Amendments to the Drawings:

REMARKS

Objections to the Drawings

FIGURE 1
PRIOR ART

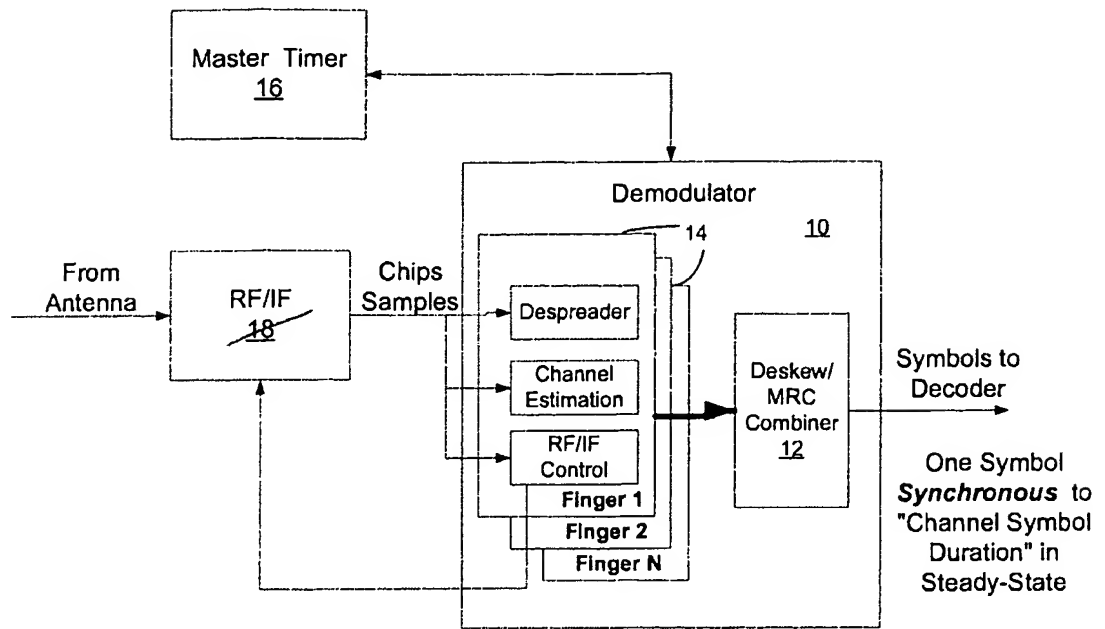
The drawings were objected to for certain informalities. Applicant has submitted herewith new formal drawing sheets to be substituted for previously submitted drawing sheets. With respect to the objections to Figure 1, Applicant respectfully notes that reference character "16" is mentioned in the specification in paragraph [0006].
